**SITE DEVELOPMENT PLANS**

## 1360 WALTON BLVD

### PROPOSED STARBUCKS

PARCEL ID: 15-09-476-030  
1360 WALTON BOULEVARD  
CITY OF ROCHESTER HILLS  
OKLAHOMA COUNTY, MICHIGAN

TITLE:  
**UTILITY PLAN**

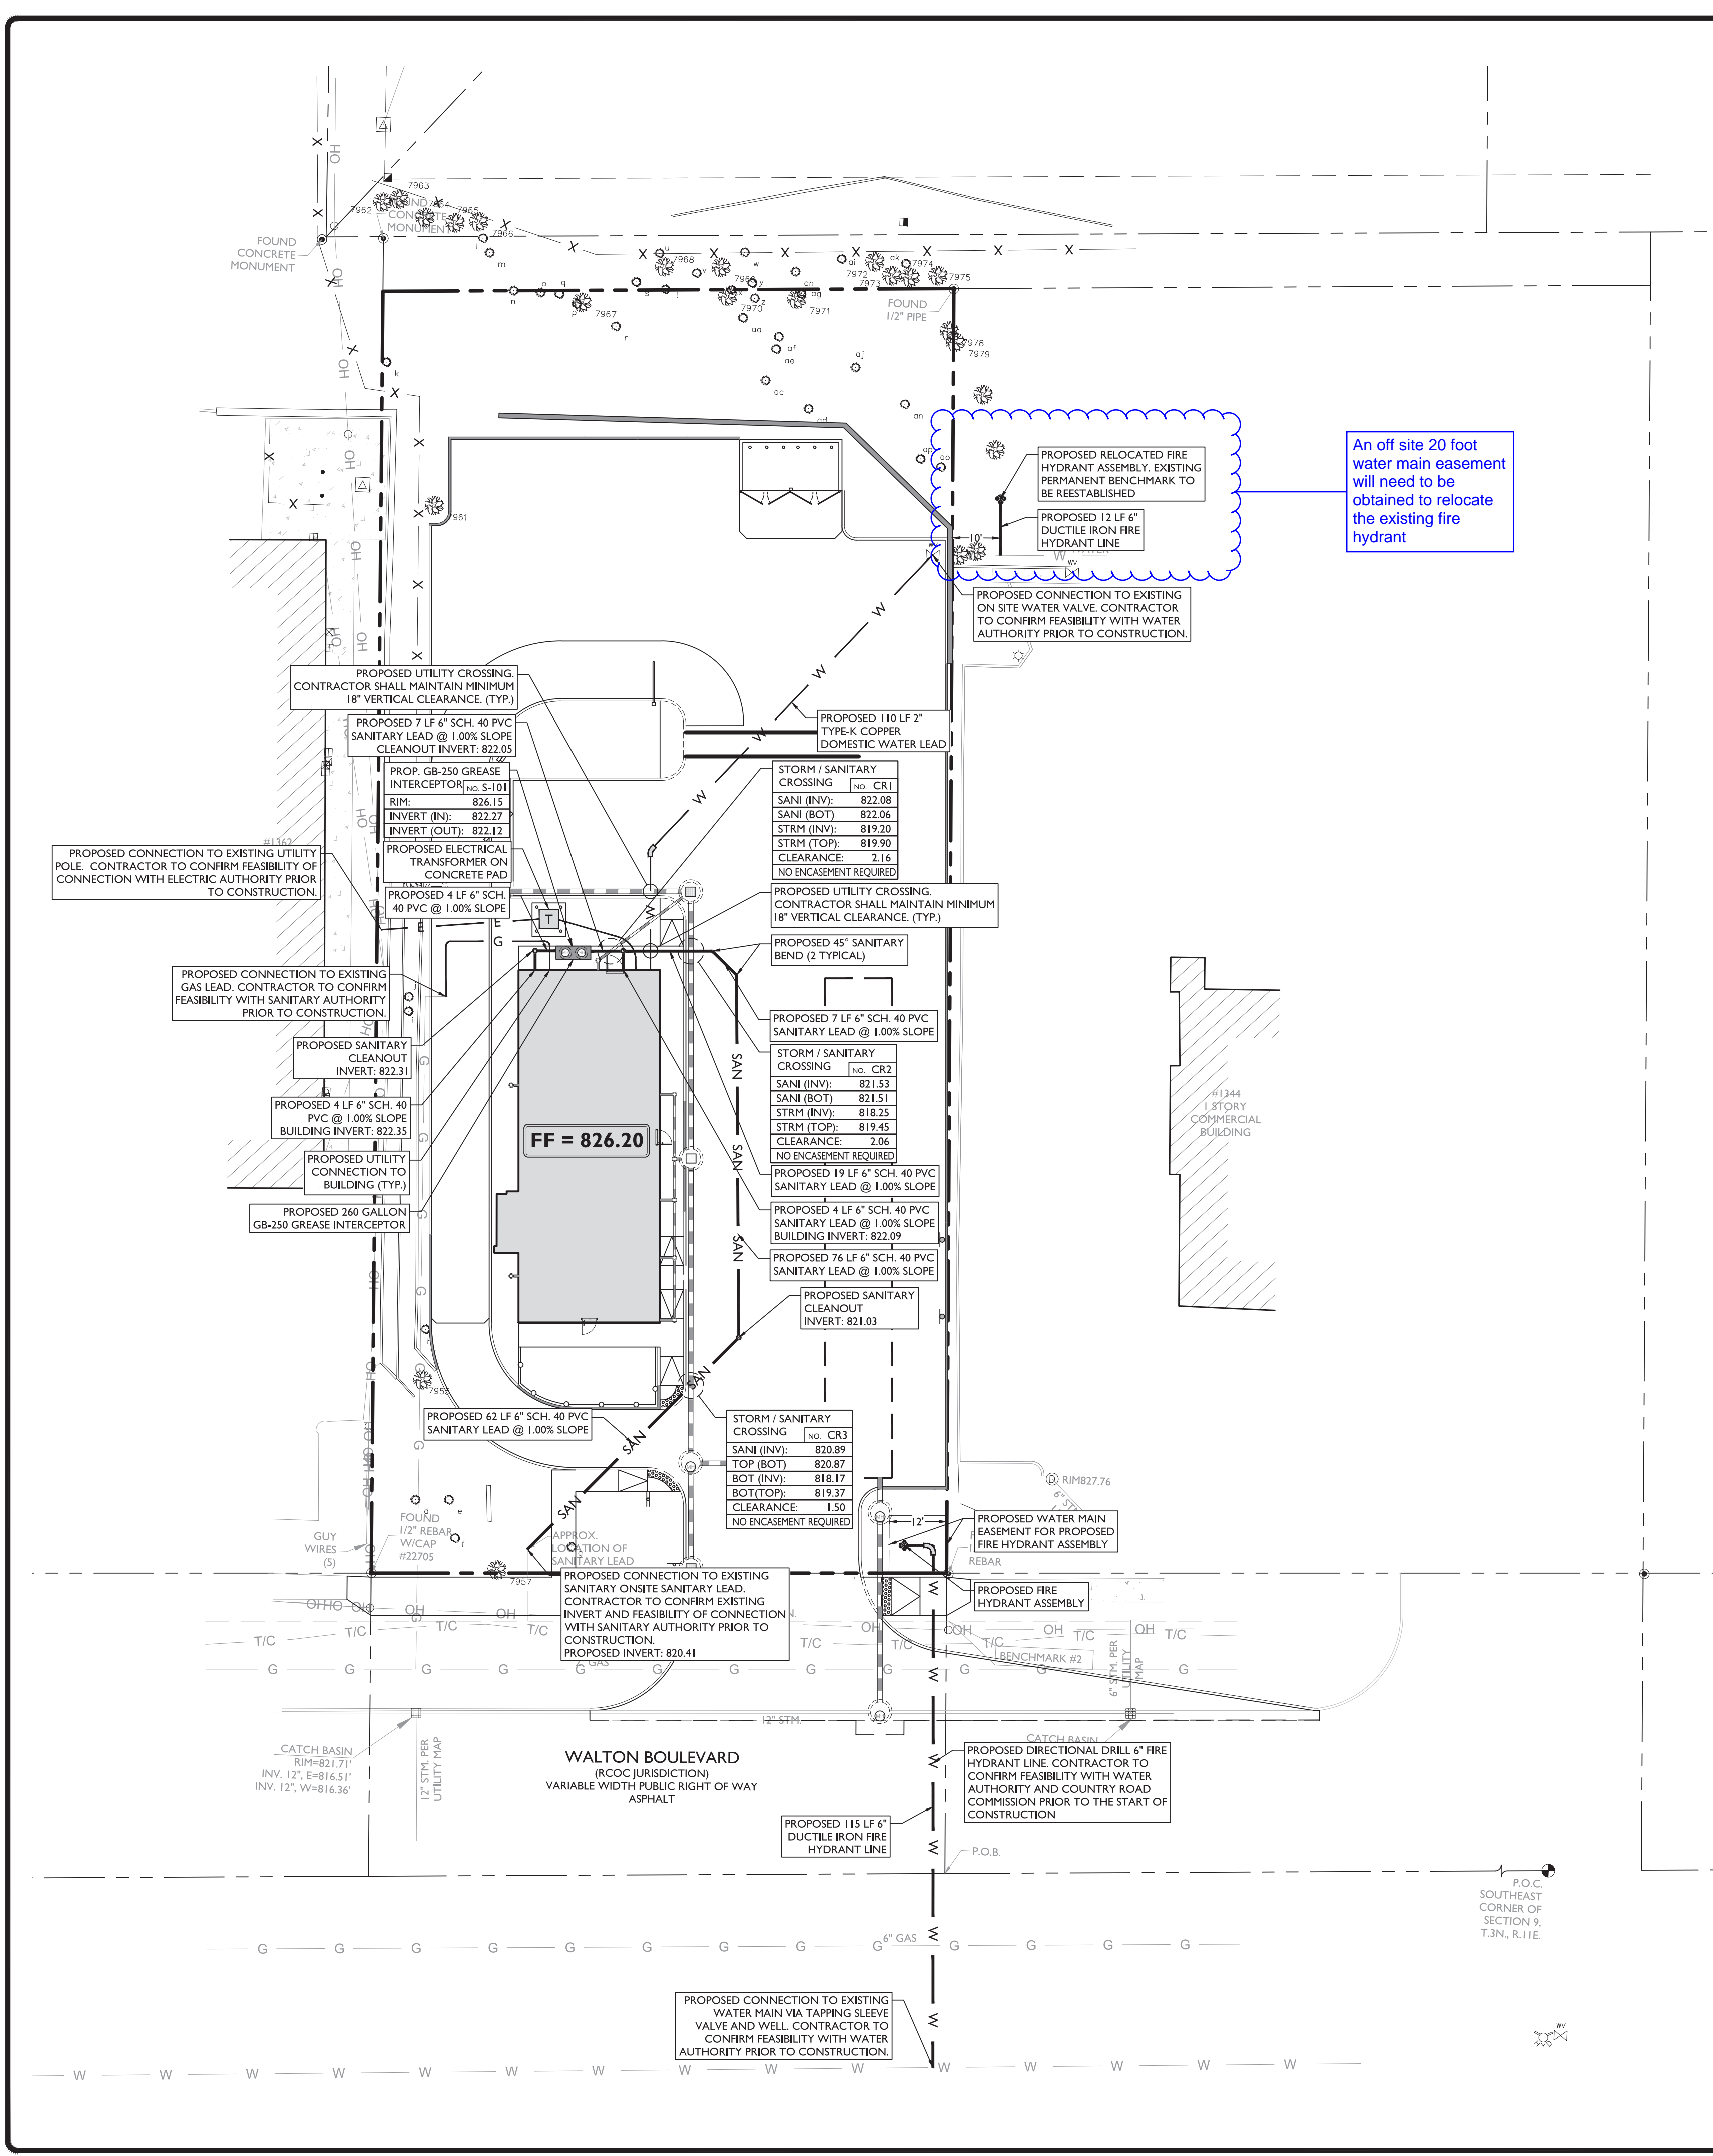
An off site 20 foot water main easement will need to be obtained to relocate the existing fire hydrant

**LANDSCAPING PLAN**

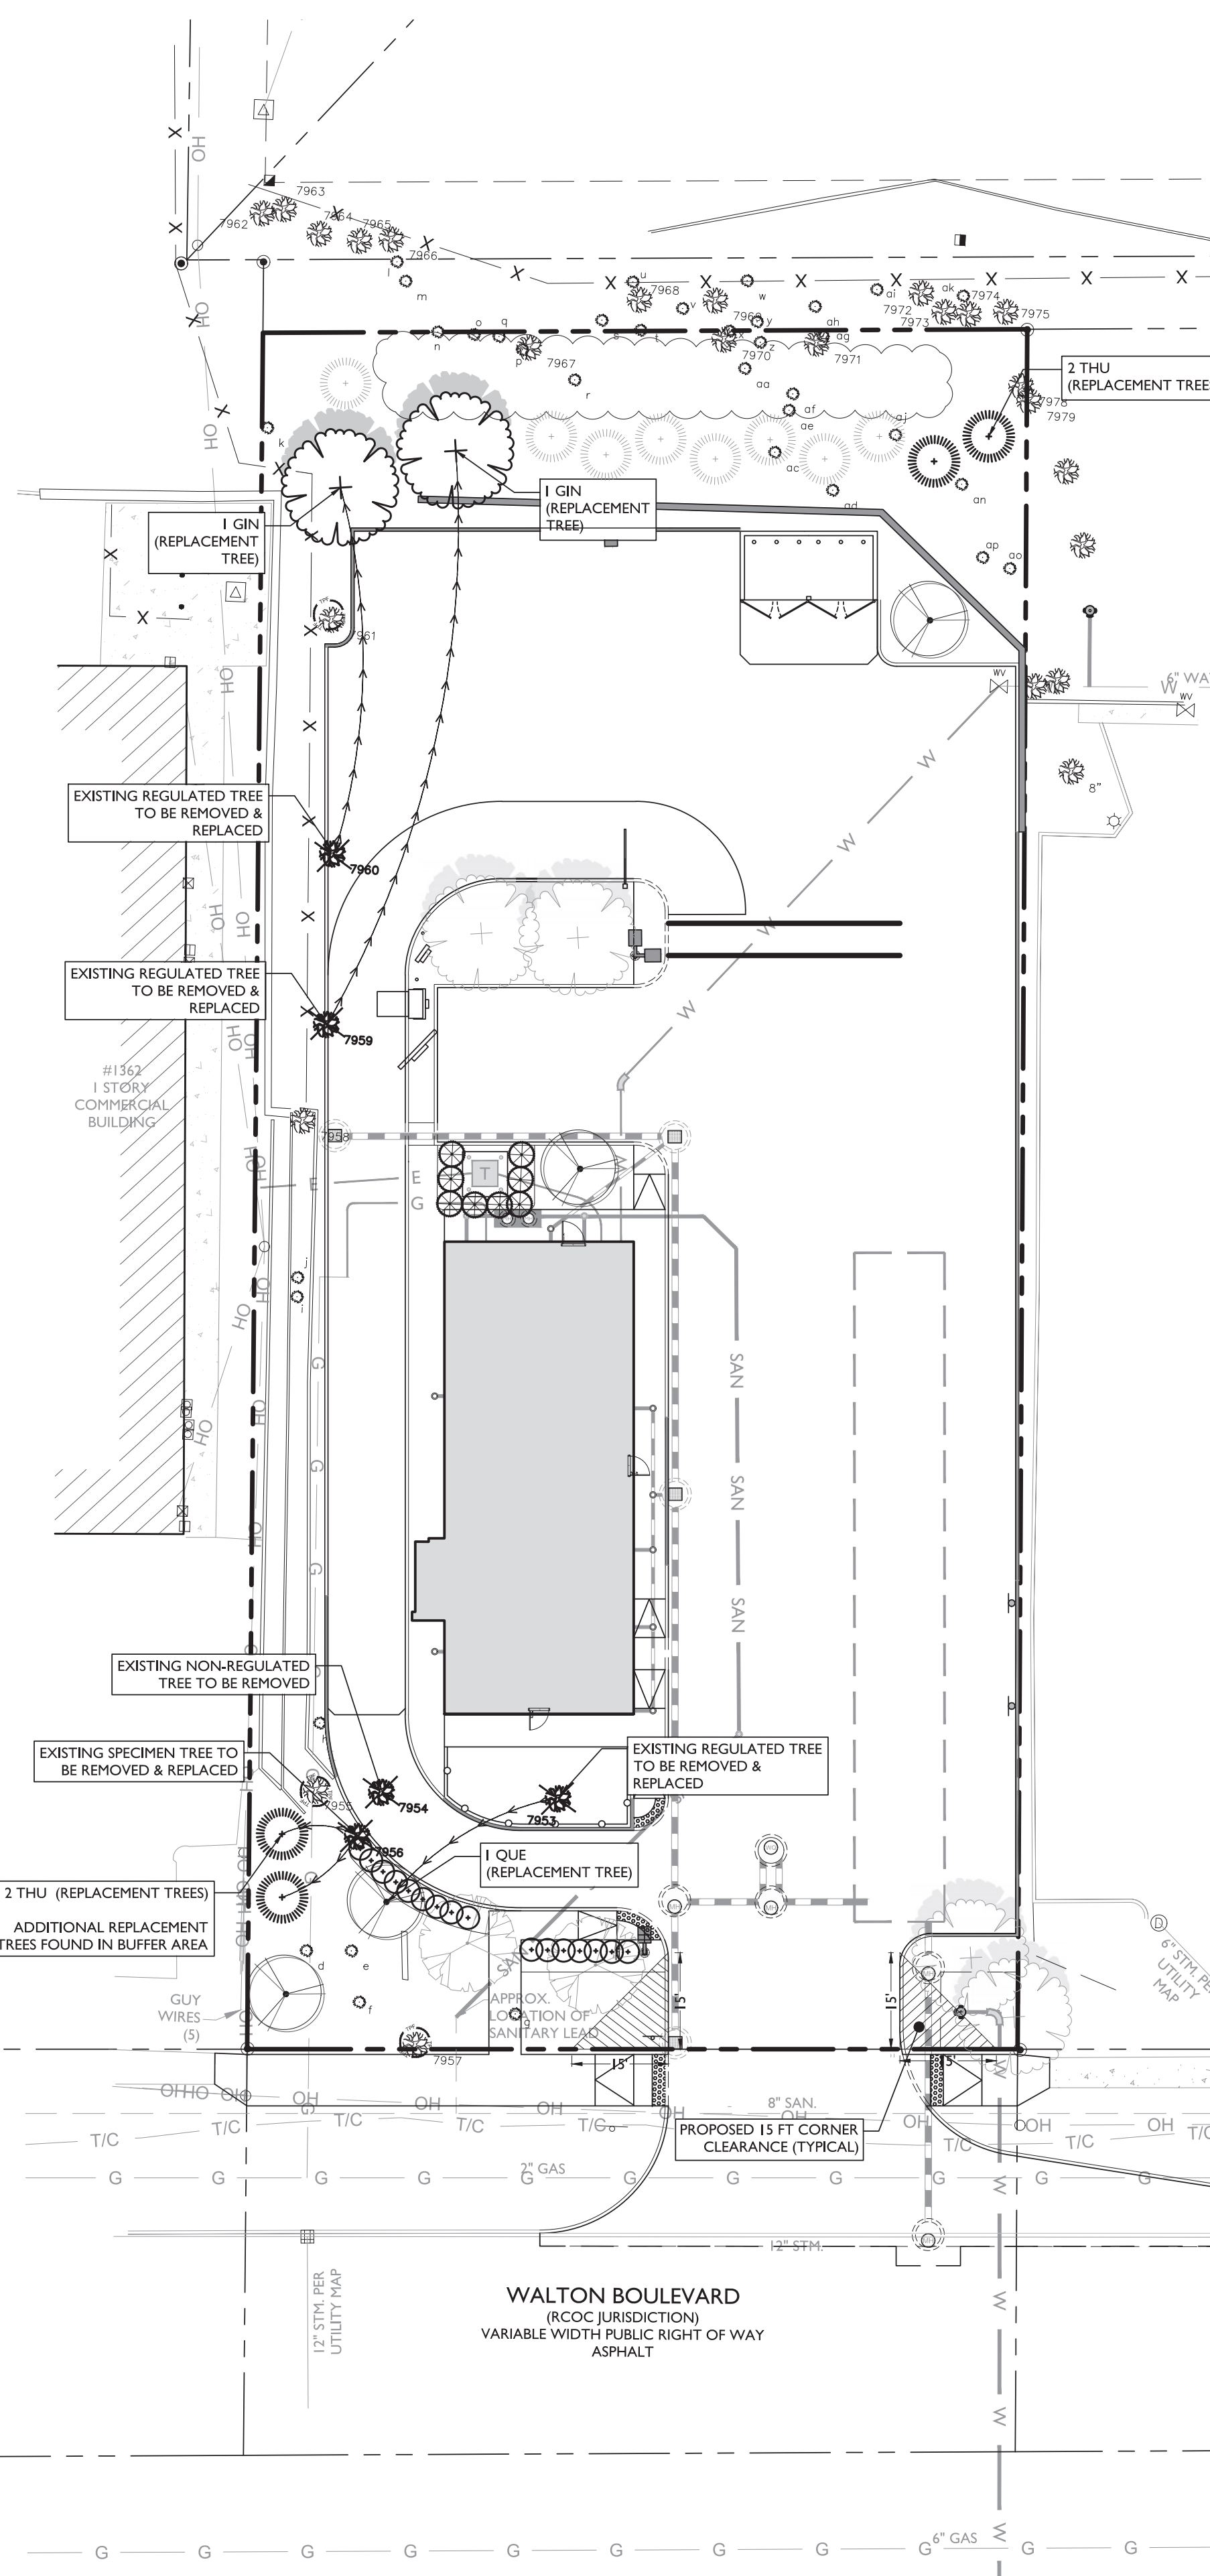
Include Road and Pathway Sight Lines. See attached details and include with the plan detail sheets.

The response letter indicates the submission of a landscape cost estimate but this could not be identified in the plans. A landscape planting cost estimate including irrigation should be provided.
